Transmitted by the expert from OICA

PROPOSAL FOR DRAFT AMENDMENTS TO REGULATION No. 34

Note: The text reproduced below was prepared by the expert from OICA in order to introduce new parts III and IV into the Regulation, allowing the possibility for approvals to be granted for fuel tanks as separate technical units. The modifications to the existing text of the Regulation are marked in **bold** or ~~striketrough~~ characters.

"Model B  
(see paragraph **3.1.5.** ~~3.5.~~ of this Regulation)

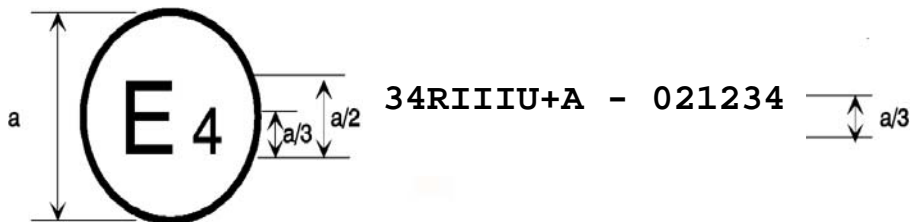
The above ..... Regulations Nos. 34 Parts I **or** IV and II and 33 \*/. The .... original form. "

"**Model C**  
(see paragraph **3.2.4.** of this Regulation)

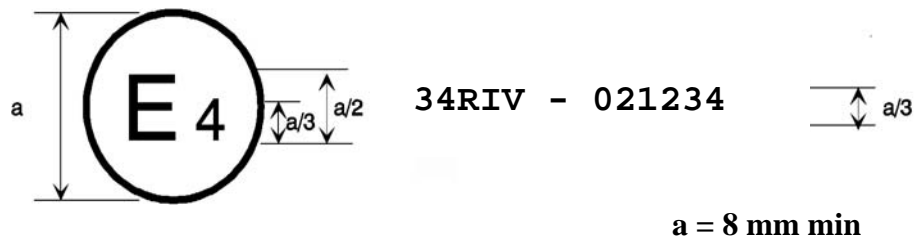
**a = 8 mm min**

**The above approval mark affixed to a fuel tank shows that the type concerned was approved in the Netherlands (E4) pursuant to Part III of Regulation No. 34, for a universal use including its accessories, under approval No. 021234. The first two digits (02) of the approval number indicate that the approval was granted in accordance with the requirements of Regulation No. 34 as amended by the 02 series of amendments.**

**Model D**  
(see paragraph 3.3.4. of this Regulation)

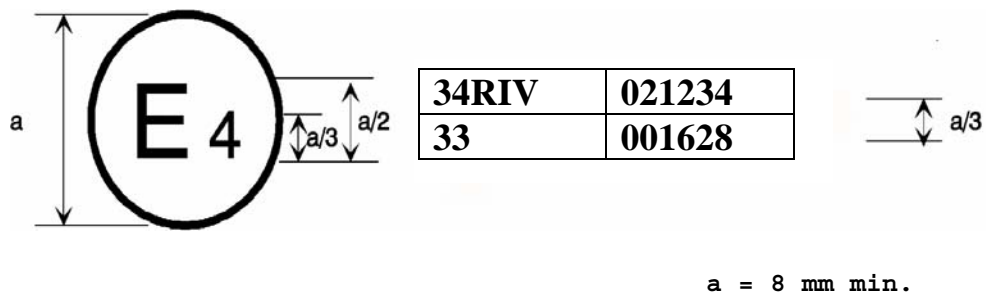
The above approval mark affixed to a vehicle shows that the type concerned was approved in the Netherlands (E4) pursuant to Part IV of Regulation No. 34 under approval No. 021234. The first two digits (02) of the approval number indicate that the approval was granted in accordance with the requirements of Regulation No. 34 as amended by the 02 series of amendments.
